Agenda
Village of Arlington Heights
Design Commission
Community Room, 3rd Floor

Arlington Heights Village Hall
33 S. Arlington Heights Road
Arlington Heights, IL 60005
May 26, 2015
6:30 PM

**MINUTES OF
THE VILLAGE OF ARLINGTON HEIGHTS
DESIGN COMMISSION MEETING
HELD AT THE ARLINGTON HEIGHTS MUNICIPAL BUILDING
33 S. ARLINGTON HEIGHTS RD.
MAY 12, 2015**

A3.2

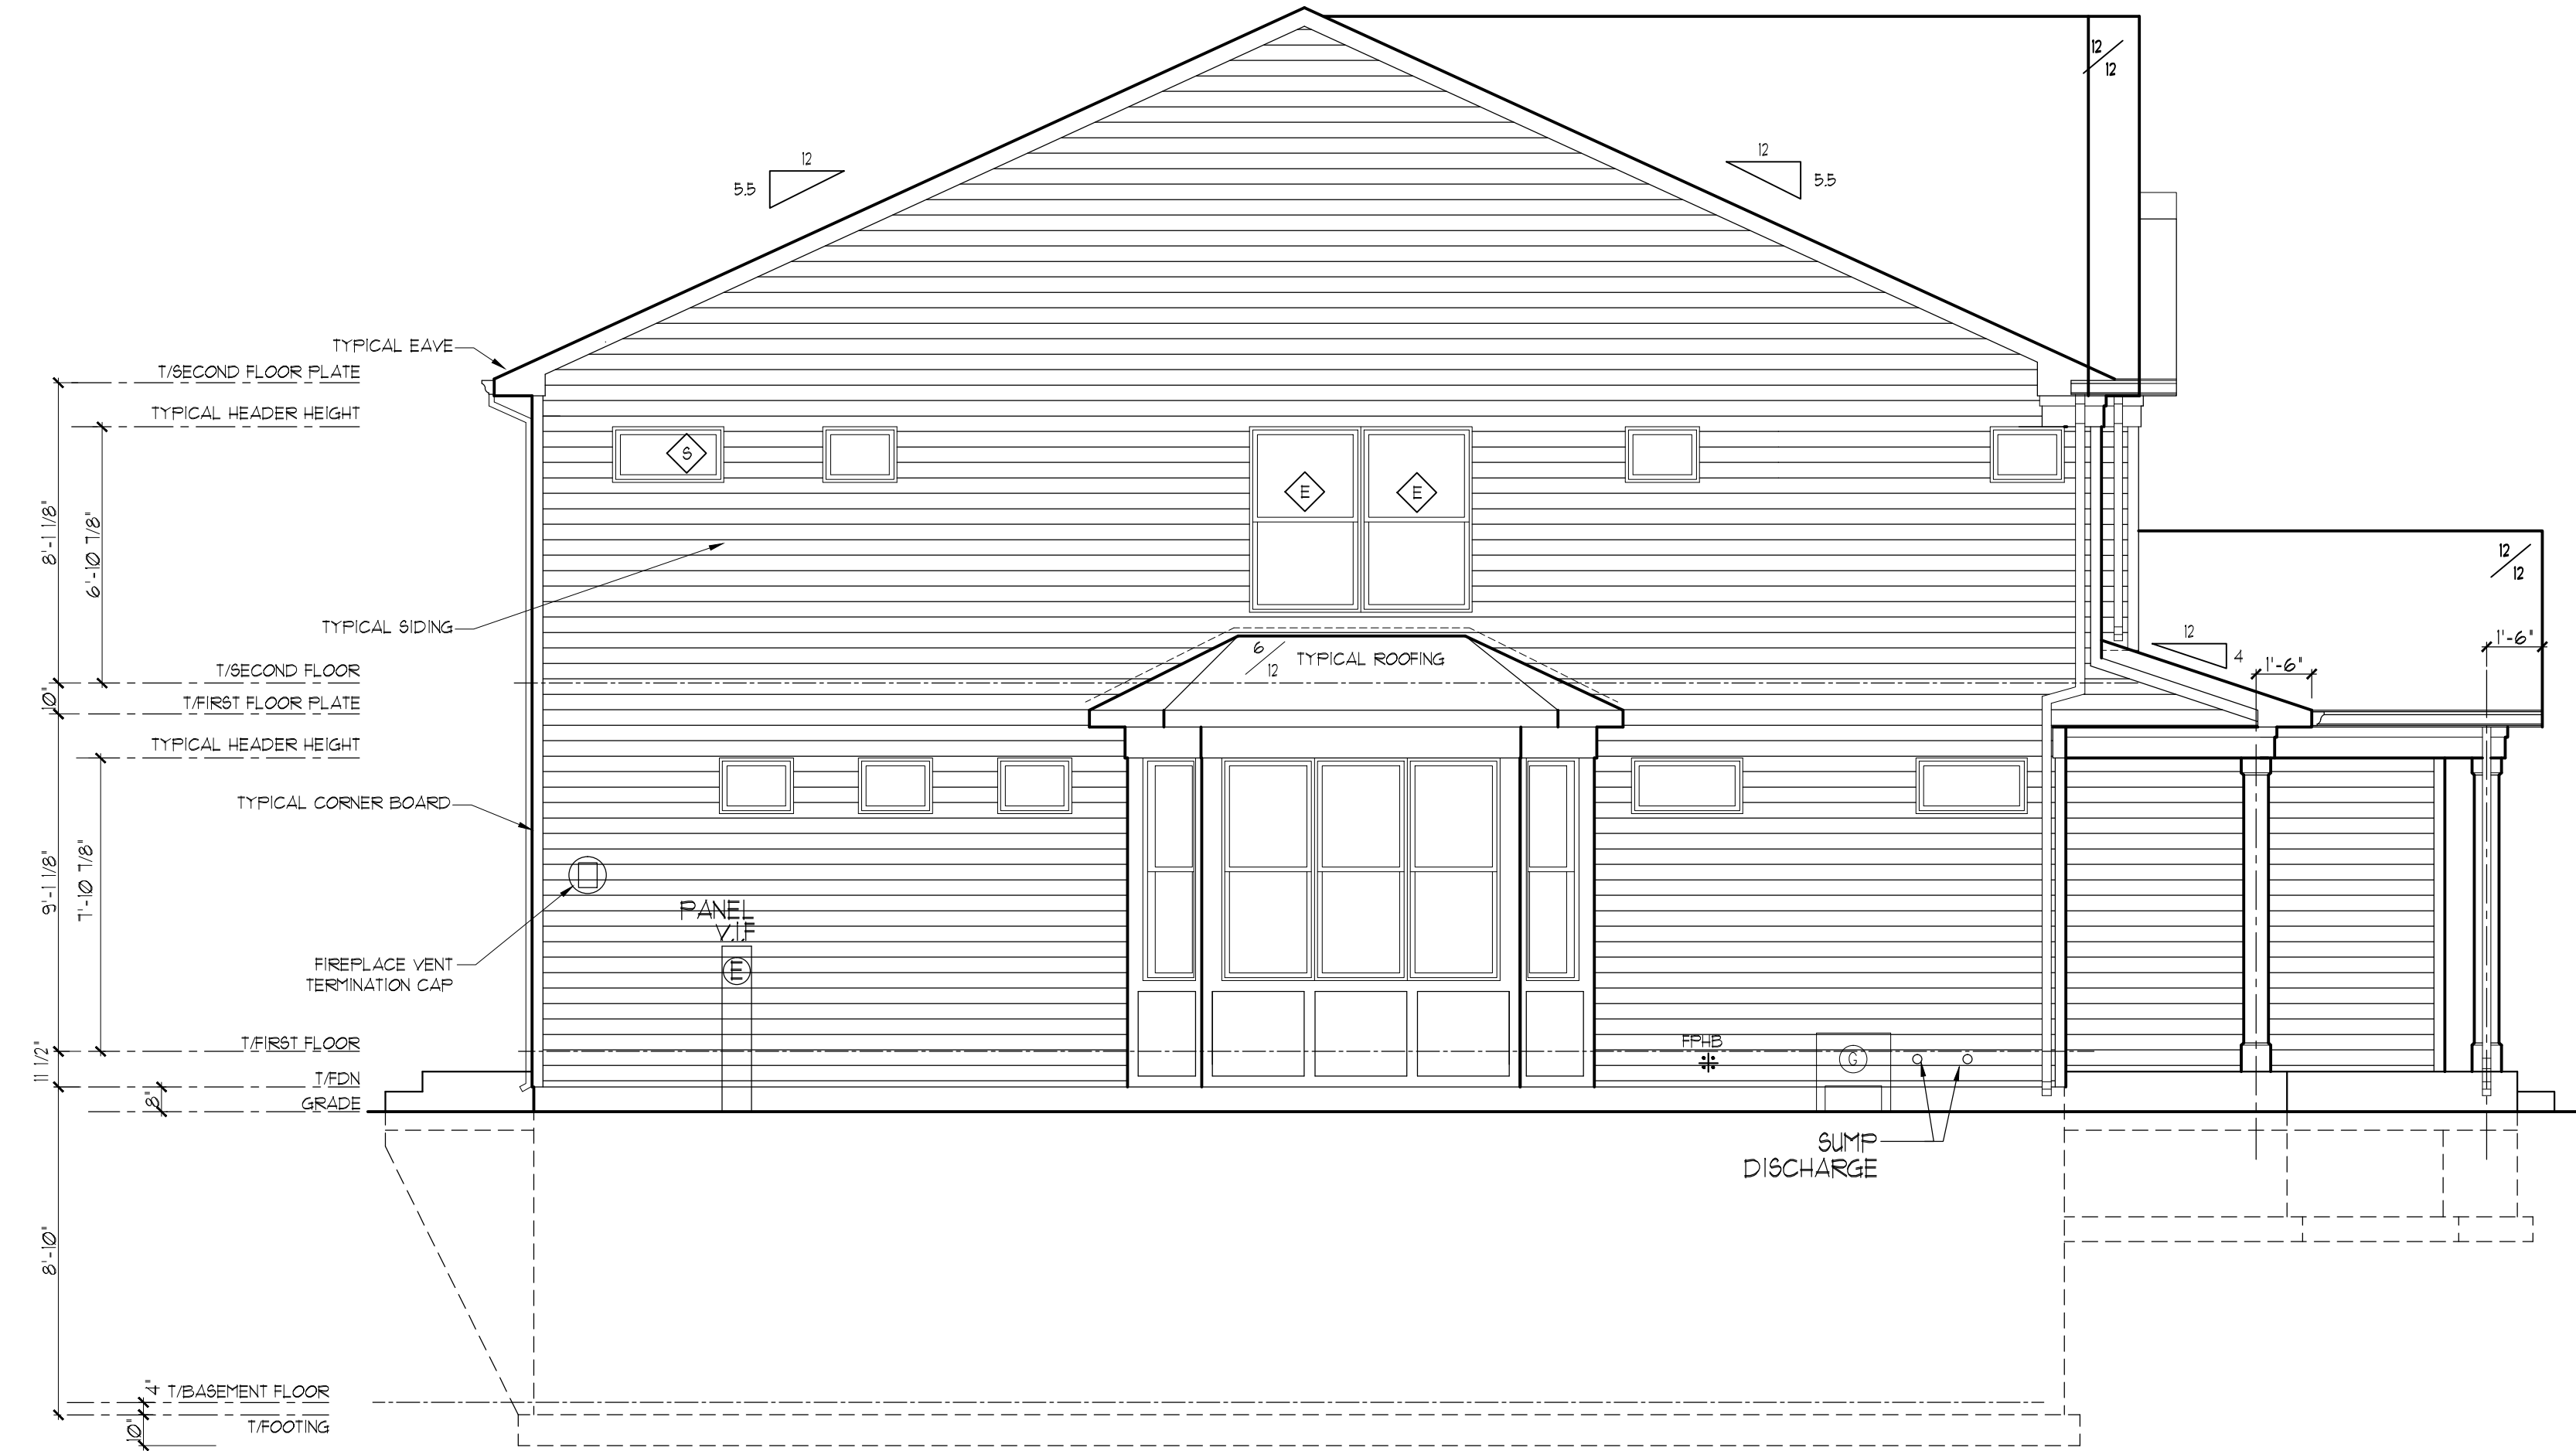
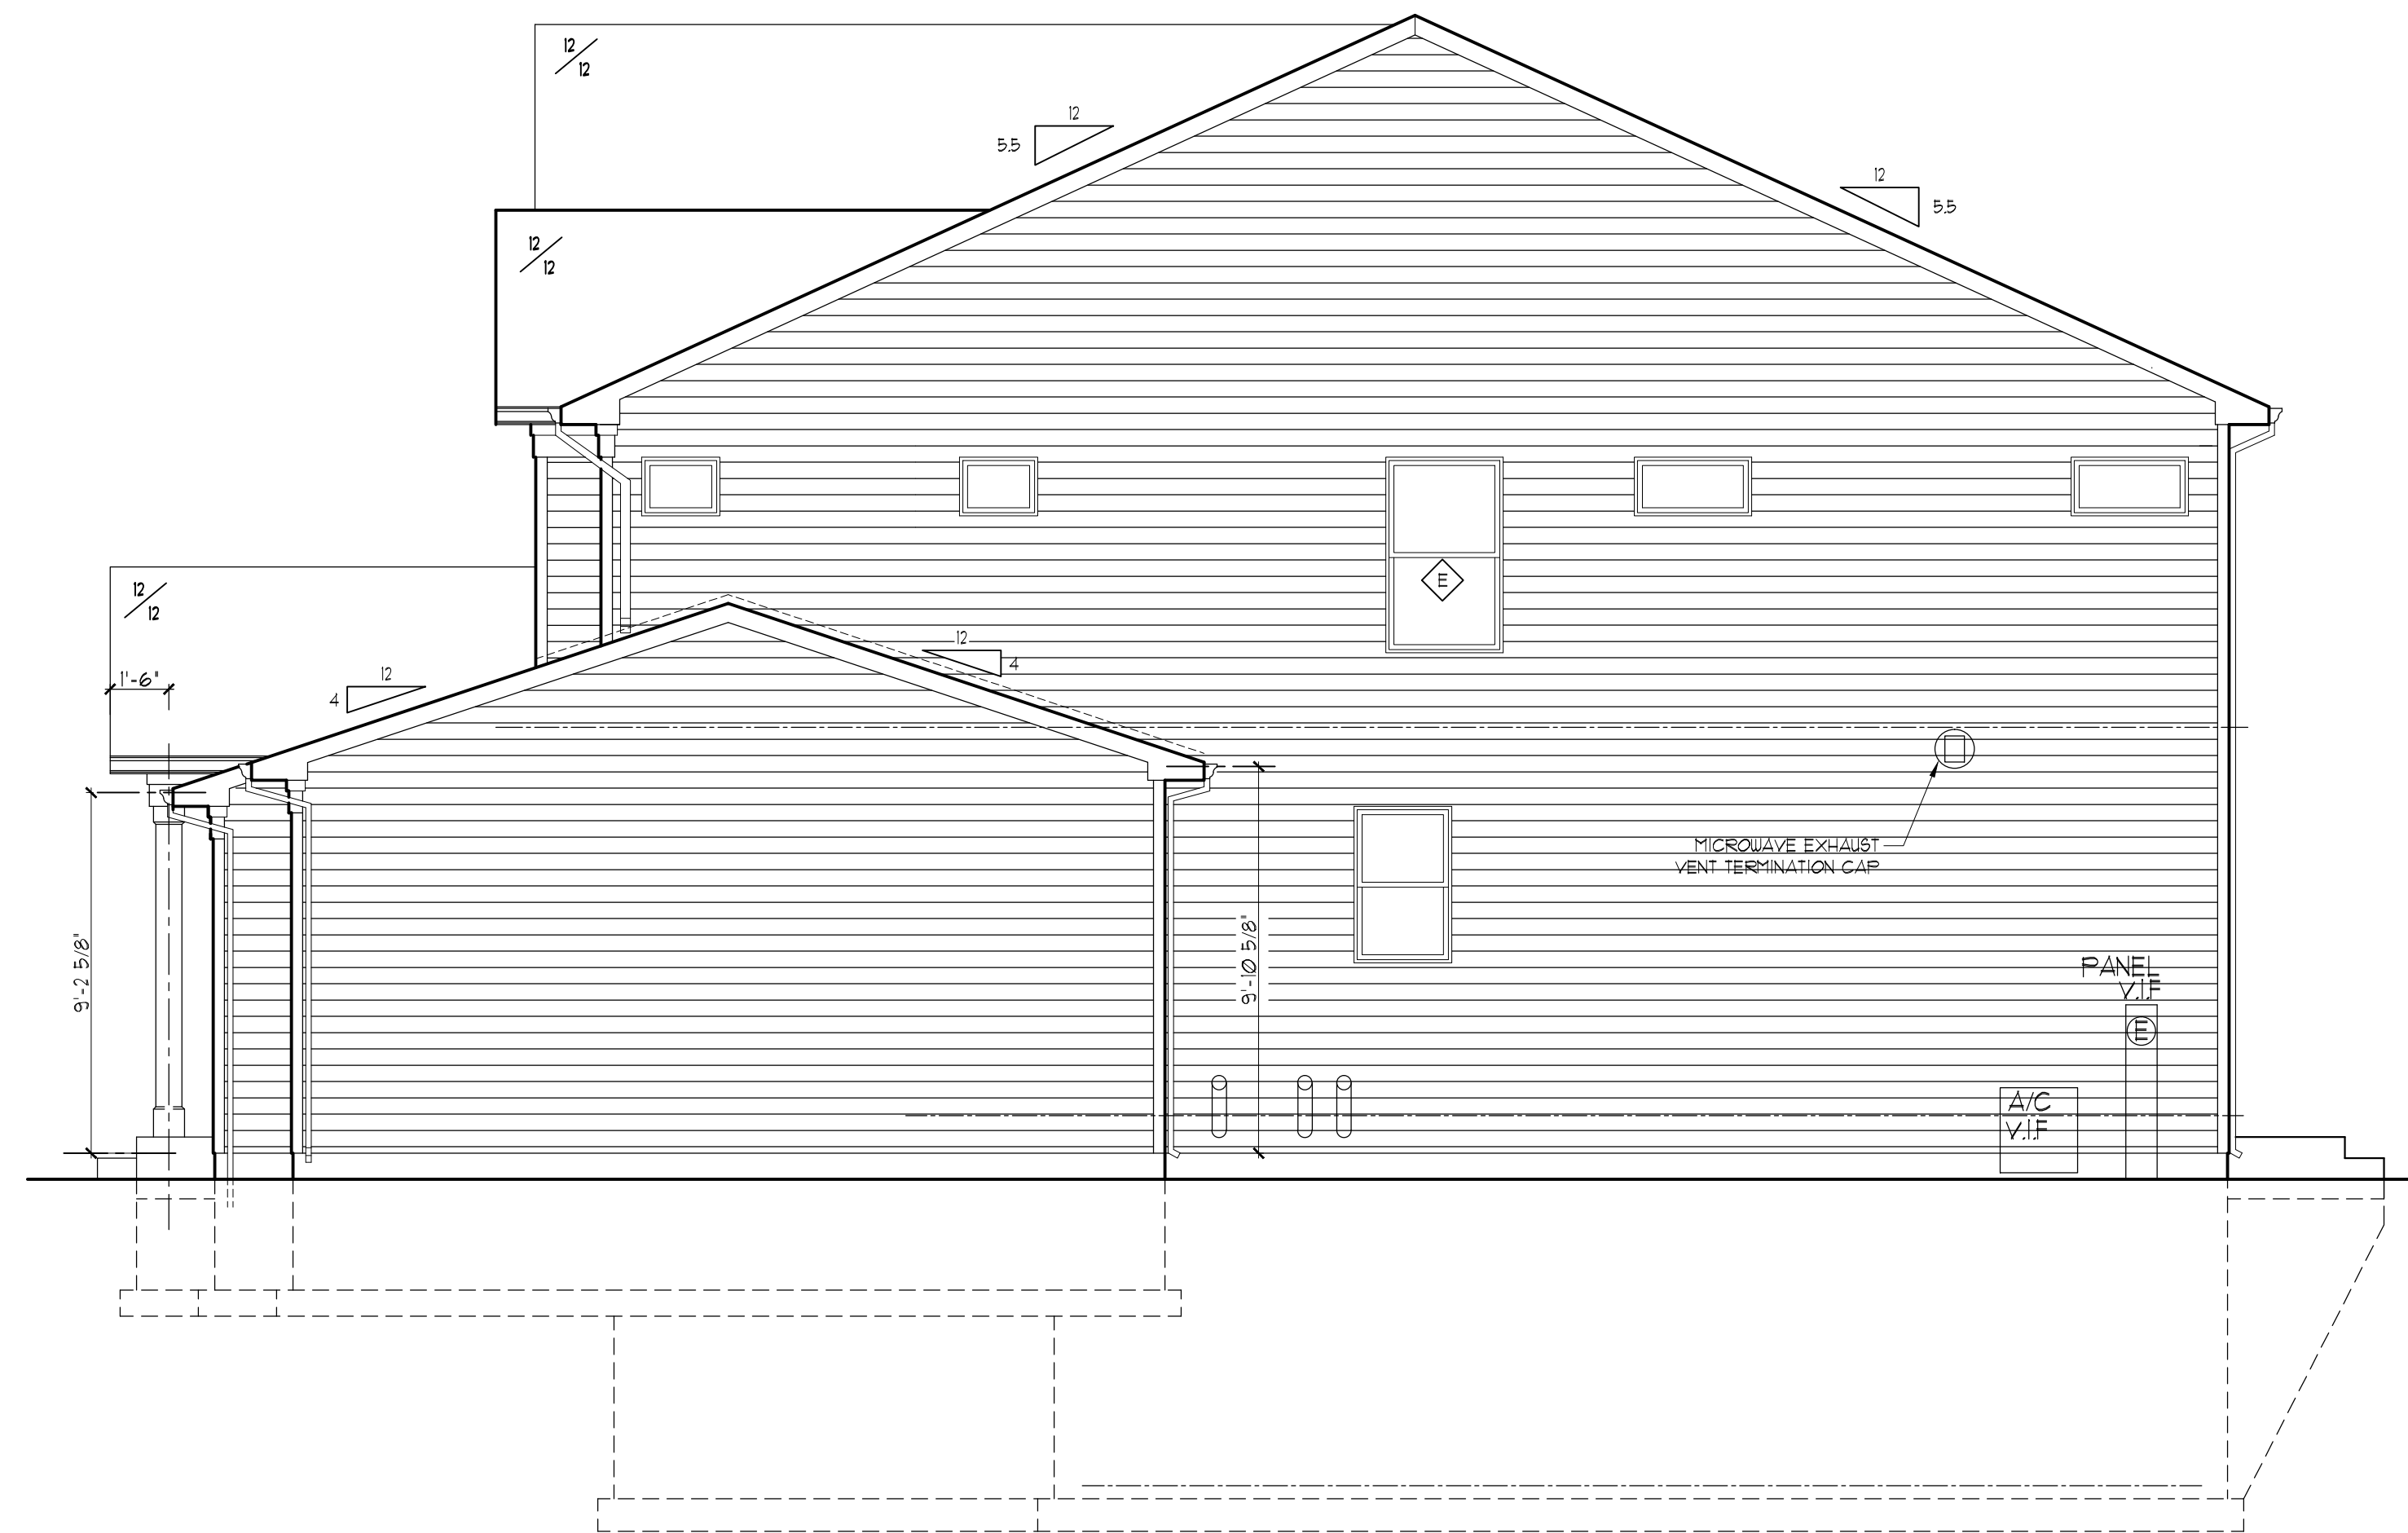
In response to the Design Commissioners comments, the petitioner has provided revised exterior elevations with the following improvements:

1. Window grids have been added to all windows on all sides of the home.
2. The side gables have been developed with the same detailing as the front elevation.
3. Horizontal trim boards have been added at the second floor line and roof line.
4. Full size windows have been added to the left side elevation.

The revised design now has an overall cohesive appearance and is nicely done. However, the Design Commission should still evaluate the appropriateness of the proposed home with the context of the neighborhood.

1. A recommendation to further recess the proposed third car garage stall.
2. This review deals with architectural design only and should not be construed to be an approval of, or to have any other impact on, any other zoning and/or land use issues or decisions that stem from zoning, building, signage or any other reviews. In addition to the normal technical review, permit drawings will be reviewed for consistency with the Design Commission and any other Commission or Board approval conditions. It is the architect/homeowner/builder's responsibility to comply with the Design Commission approval and ensure that building permit plans comply with all zoning code, building permit and signage requirements.
3. Compliance with all applicable Federal, State, and Village codes, regulations and policies.
